REVIEW OF WATER DEMAND AND UTILIZATION
STUDIES FOR THE PROVO RIVER DRAINAGE BASIN,
AND REVIEW OF A STUDY OF THE EFFECTS OF THE
PROPOSED JORDANELLE RESERVOIR ON SEEPAGE TO
UNDERGROUND MINES, BONNEVILLE UNIT OF THE
CENTRAL UTAH PROJECT

By K.M. Waddell, G.W. Freethey, D.D. Susong, and G.E. Pyper

U.S. GEOLOGICAL SURVEY
Open-File Report 91-514

Figure 2.2.1-1--Projected municipal water demands for Salt Lake County under various per capita use rates.

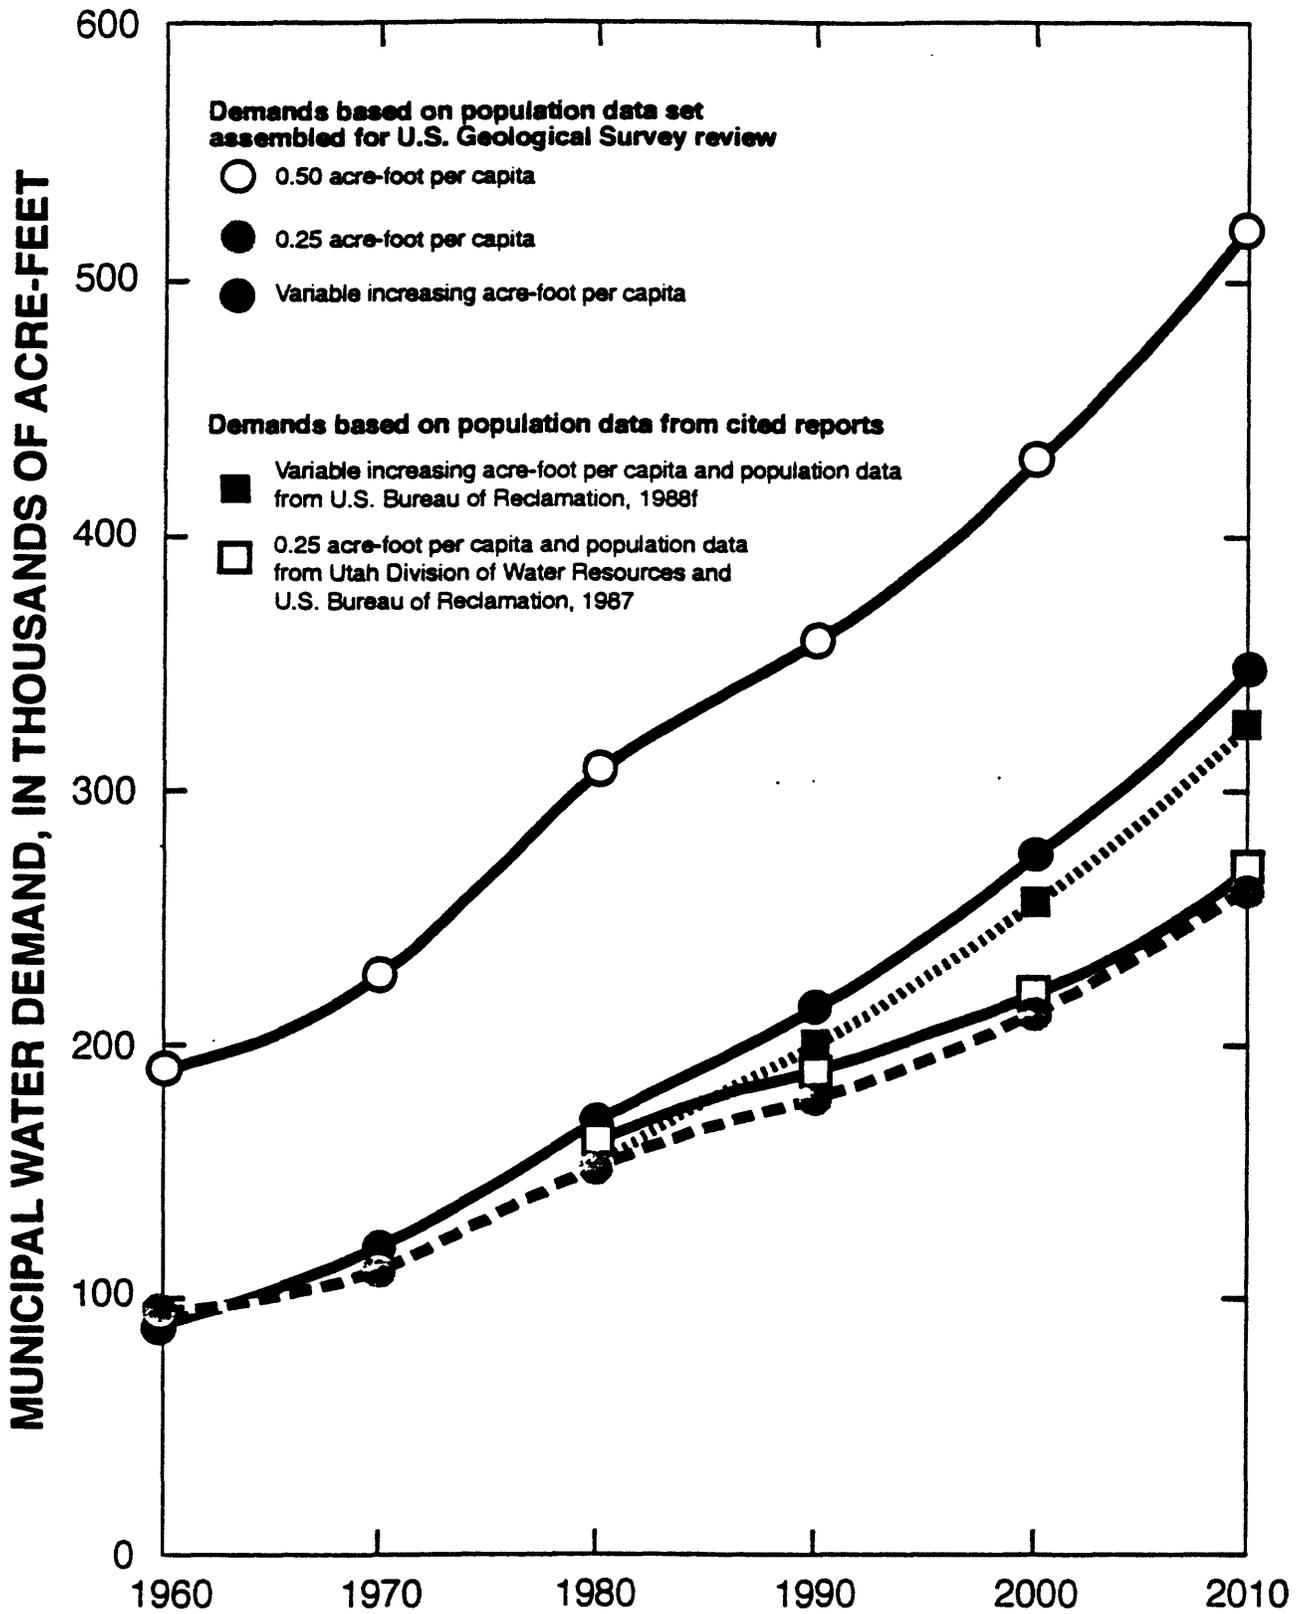
The variable increasing per capita use rate used in the Draft Supplement to the DPR (USBR, 1988f) is a conservative approach to water demand. The 0.25 acre-foot per capita use rate used in the Draft Wasatch Front Total Water Management Study, Jordan River Basin, on the other hand, is based on the assumption that per capita use rates will decline from current levels, and with increased emphasis on conservation, the lower rates will be attainable (Utah Division of Water Resources and USBR, 1990).

The Draft Supplement to the DPR (USBR, 1988f) and the Draft Wasatch Front Total Water Management Plan, Jordan River Basin (Utah Division of Water Resources and USBR, 1987), were prepared at about the same time by the USBR, and the two reports take very different approaches to projecting water demands. In the Supplement to the DPR, water conservation was not assumed. The Wasatch Front Total Water Management Study was a cooperative effort between many of the Wasatch Front water management agencies and probably reflects a broader consensus on future water demands and per capita water-use rates than the Draft Supplement to the DPR (USBR, 1988f). If a per capita use rate of 0.25 acre-foot is attainable as assumed in the Wasatch Front Total Water Management Study (Utah Division of Water Resources and USBR, 1990), then water supplies could be sufficient to fulfill the demands of Salt Lake County beyond 2010.

In the Draft Supplement to the DPR (USBR, 1988f), the water-demand curve in figure III-2 was checked against population data and per capita water-use rates in tables III-1 and III-2. Using the data in these tables and following the approach described in the text, the USGS reviewers could not reproduce the water-demand curve in figure III-2. Multiplying the population projections by the per capita water-use rates in tables III-1 and III-2 results in water demands for 2010 that are about 55,000 acre-feet greater than the values in the water-demand curve in figure III-2. The results indicate that the curve in figure III-2 might have been created from different data sets than those listed in tables III-1 and III-2 or by different methods than those documented in the report.

Figure 2.3.3-1--Calculated shortage of water for simulated operation of Jordanelle Reservoir assuming initial content is 0 and 269,500 acre-feet for operation period 1930-73.

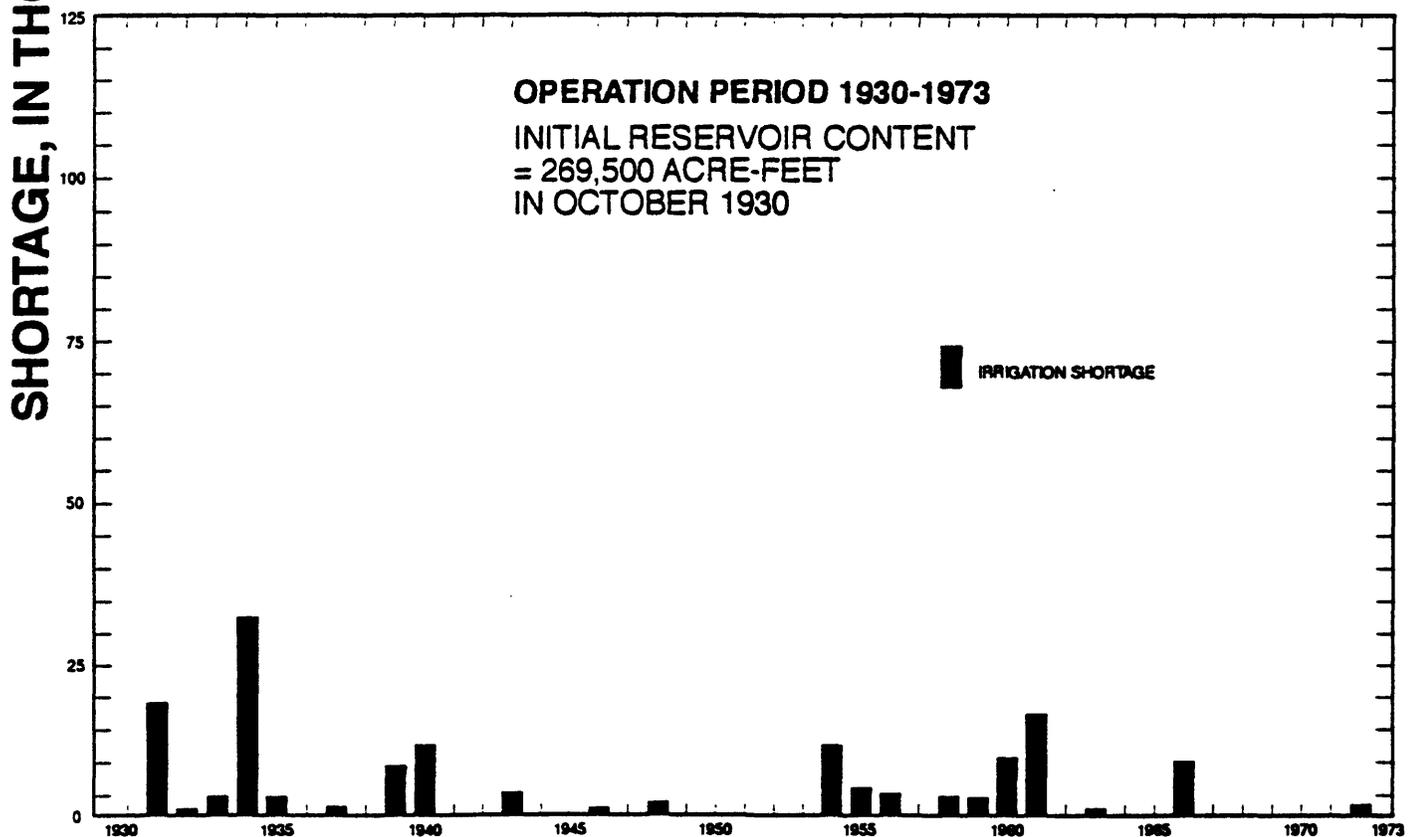
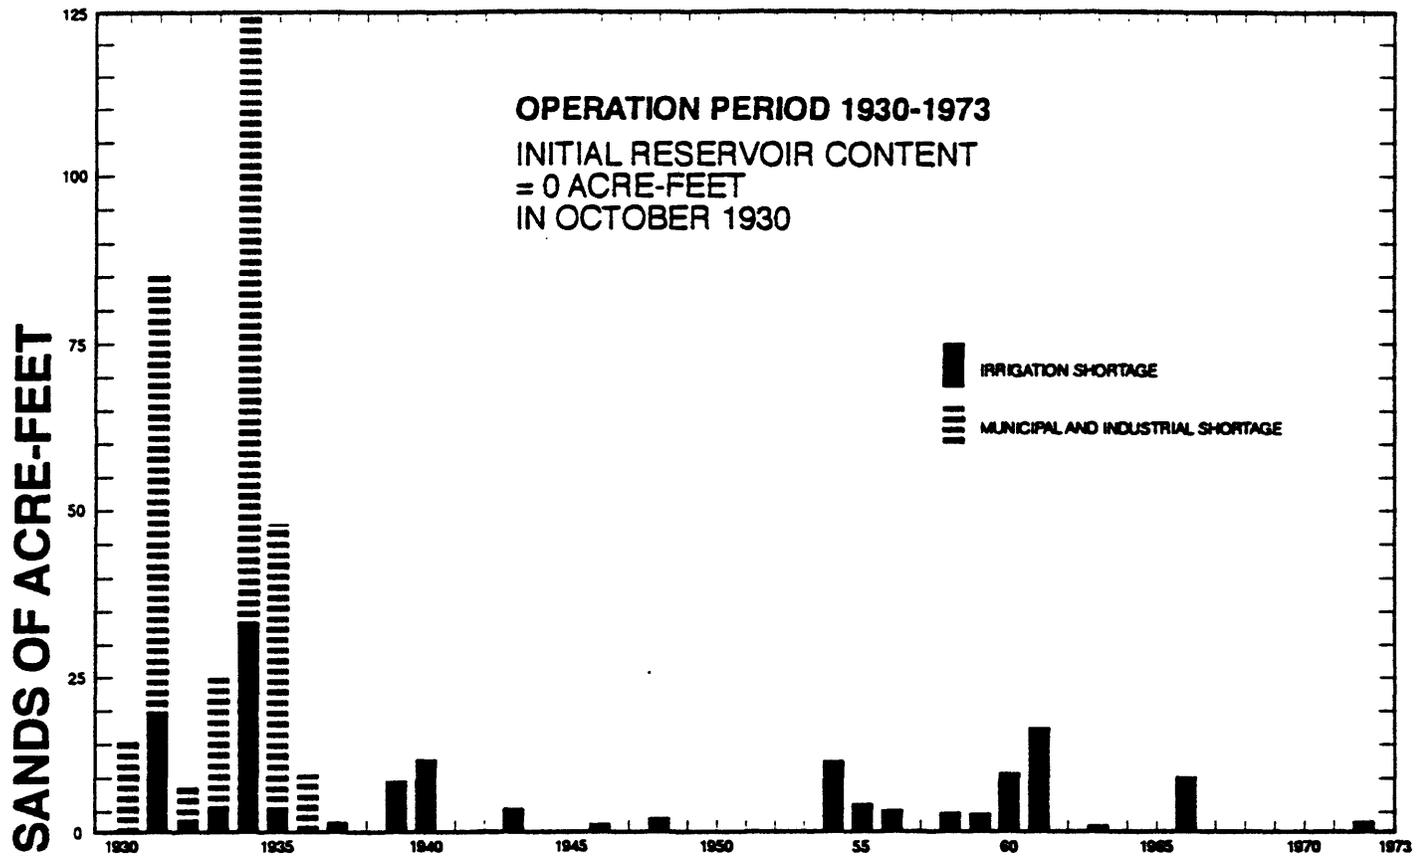
In the Jordanelle Reservoir Operation Study, the USBR assumed that the initial content of Jordanelle Reservoir was 269,500 acre-feet of water for the simulation of reservoir operation (USBR, 1988f, p. IV-55, column 78). As part of the USGS review, the model was run to determine the effects of an initial reservoir content of 0 acre-feet on shortages to the total municipal, and industrial, and irrigation water supply. Graphs of shortages for municipal, industrial, and irrigation water with the initial content of Jordanelle Reservoir set at 0 acre-feet and 269,500 acre-feet are shown in figure 2.3.3-1.

The initial shortages in municipal, industrial, and irrigation water will decrease during the initial filling of the reservoir if project demands are applied more gradually as will probably be the case when Jordanelle Reservoir actually begins operation. In actual operation, water will not be provided from Jordanelle Reservoir until the water is stored and available in the reservoir. In the model, shortages of municipal and industrial water occur when the initial contents of Jordanelle Reservoir is set at 0 acre-feet because the model operates with full project demands applied from the beginning of the simulated period while the reservoir is filling.

No municipal and industrial water shortages occurred in the base period (1930-73) when Jordanelle Reservoir was simulated with an initial content of 269,500 acre-feet in 1930. However, when the initial content was simulated as 0 acre-feet in 1930, considerable shortages of municipal and industrial water existed in the 1930's (fig. 2.3.3-1). Under actual reservoir operating conditions, shortages of irrigation water would also occur in years with municipal and industrial water shortages, but in this simulation they did not. Thus, the model does not compute shortages to irrigation as a function of reservoir contents. Under a more realistic approach, shortages in the 15,100 acre-feet of supplemental irrigation water to be supplied to the Heber and Francis areas would occur before any municipal and industrial water shortages occurred.

Fig 2.3.3-2--Effects of reducing or increasing past modified flow at Hailstone on shortage of supply to Heber area.

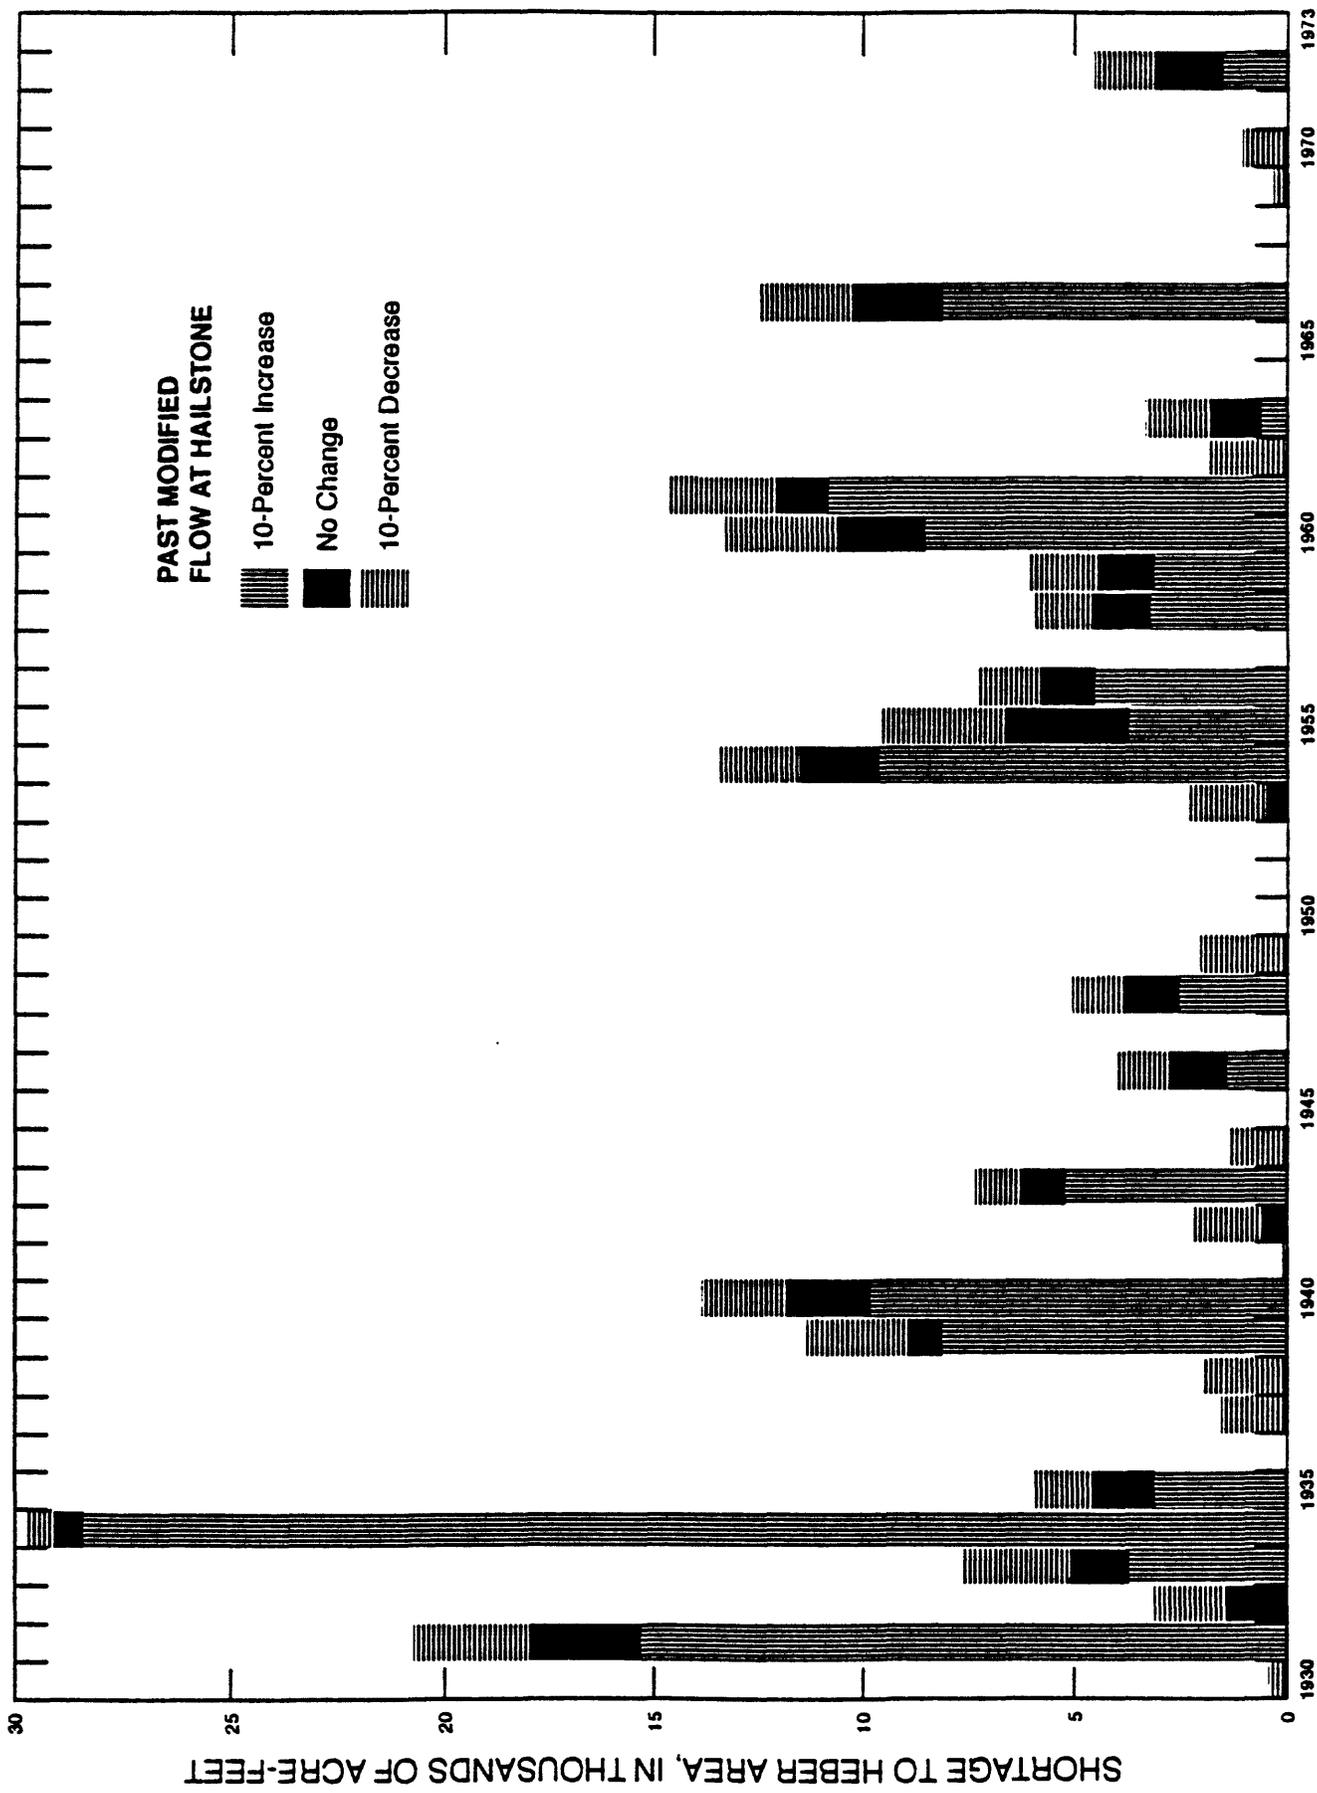
Irrigation shortages to the Heber area (column 63, fig. 6.0-4) are computed in an operation study and are entered directly into the model. This operation study was not available for the USGS review. Apparently, the USBR examined the past modified flows at Hailstone as part of this operation study and prorated the irrigation shortages to the Heber area for the 1930-73 simulation based on the streamflow at Hailstone. The response of the Jordanelle Reservoir Operation Study model was evaluated for a change (plus or minus 10 percent) in the past modified flow at Hailstone (column 37, fig. 6.0-4), and it was determined that the shortages to the Heber area (column 63, figure 6.0-4) varied as a function of the change in flow at Hailstone (fig. 2.3.3-2).

Figure 2.3.3-3--Calculated shortage of water for simulated operation of Jordanelle Reservoir assuming initial content is zero for operation periods 1941-73, 1952-73, and 1963-73.

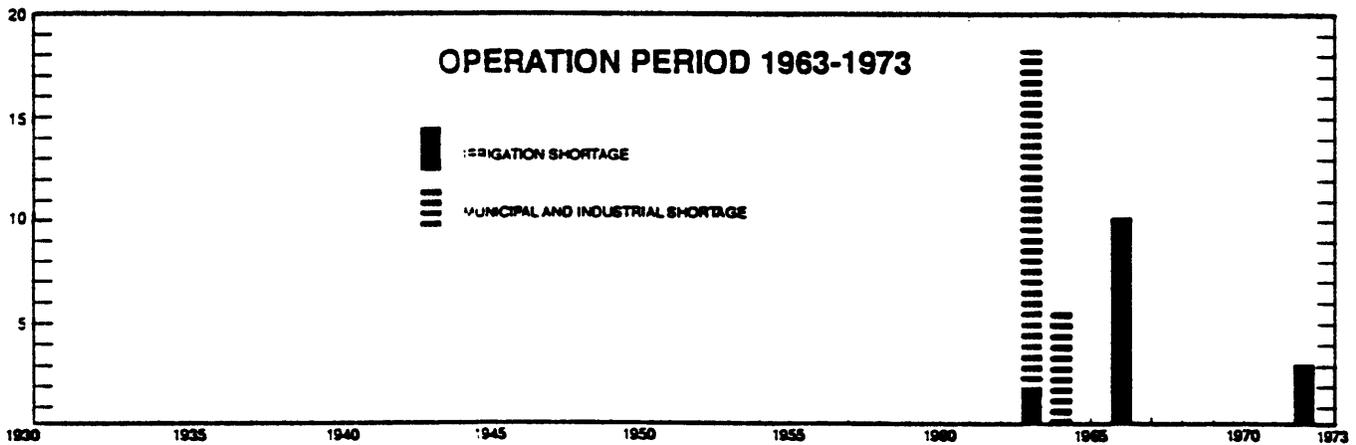
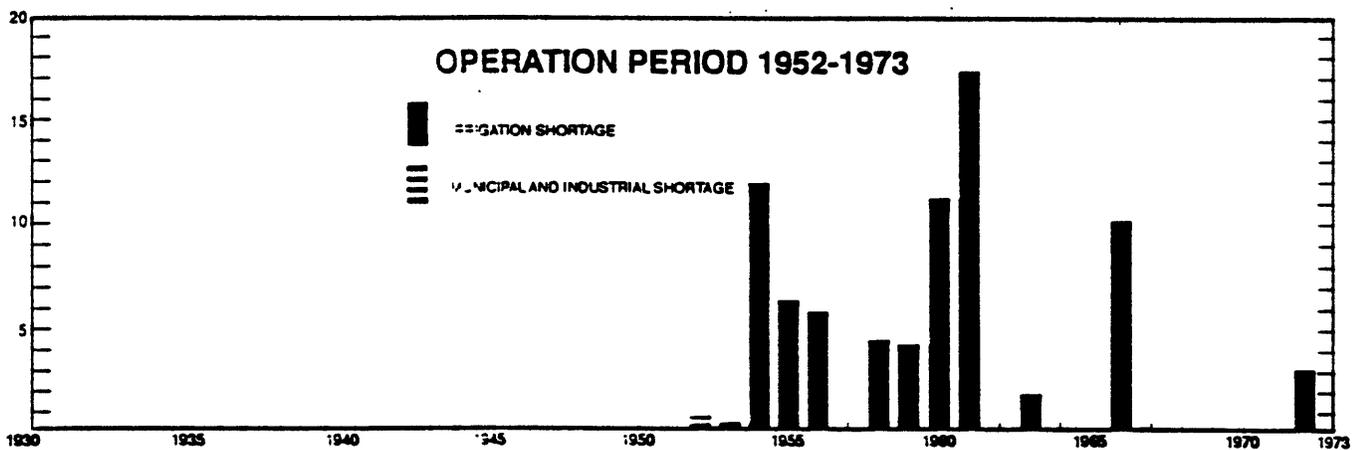
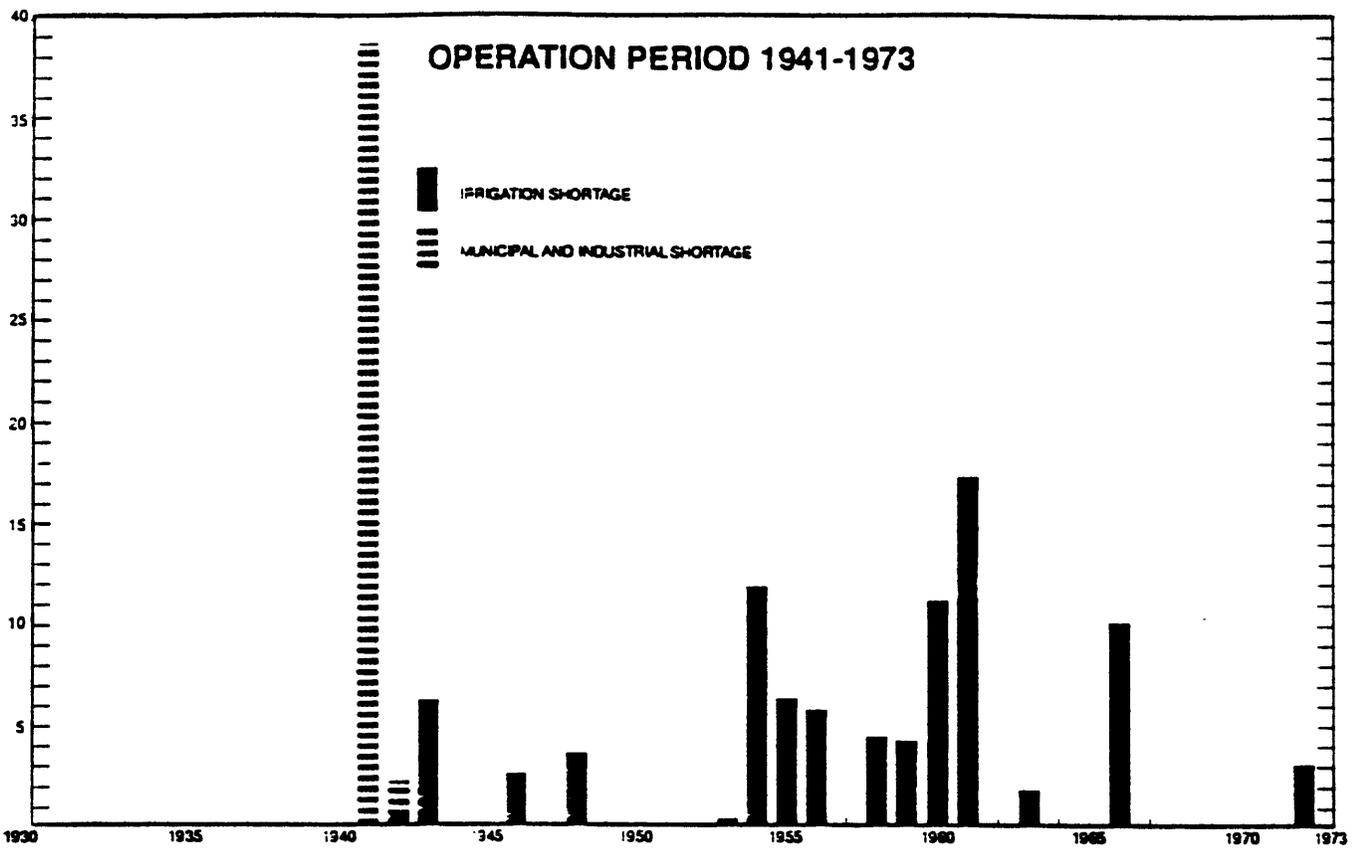
Four model runs were made with the initial reservoir contents set at 0 at the beginning of each of the four simulation periods, 1930-73, 1941-73, 1952-73, and 1963-73. The shortages to municipal, industrial, and irrigation supply are shown in figures 2.3.3-1 and 2.3.3-3. As previously stated, the model is not programmed to vary shortages to irrigation as a function of reservoir contents, so irrigation shortages do not respond to changes in reservoir content and are not considered in the following discussion.

The 1930's were a drought period with less-than-average streamflows. For the 1930-73 simulation, municipal and industrial shortages were indicated during 1930-36 while Jordanelle Reservoir was slowly filled (fig. 2.3.3-1). For the 1941-73 simulation period (fig. 2.3.3-3), 1941 was a relatively dry year with less-than-average streamflows followed by greater-than-average streamflows during 1942-46; shortages to municipal and industrial supply occurred only during 1941-42. The 1952 water year was the wettest year of the 1930-73 base period, and only a minor shortage of municipal and industrial water occurred during the first year (1952) of the 1952-73 simulation period (fig. 2.3.3-3). The 1963 water year was relatively dry, and large shortages occurred during the first 2 years (1963-64) of the 1963-73 simulation period.

The simulations for the four periods indicate that the capability of the Jordanelle Reservoir and Bonneville Unit of the CUP to deliver the proposed water supply will depend directly on the streamflow conditions following the closure of the reservoir. Municipal and industrial shortages occurred only during the initial years following closure. The maximum time during which shortages occurred following reservoir closure was 6 years, and in the other three simulation periods, shortages only occurred during the first 2 years.
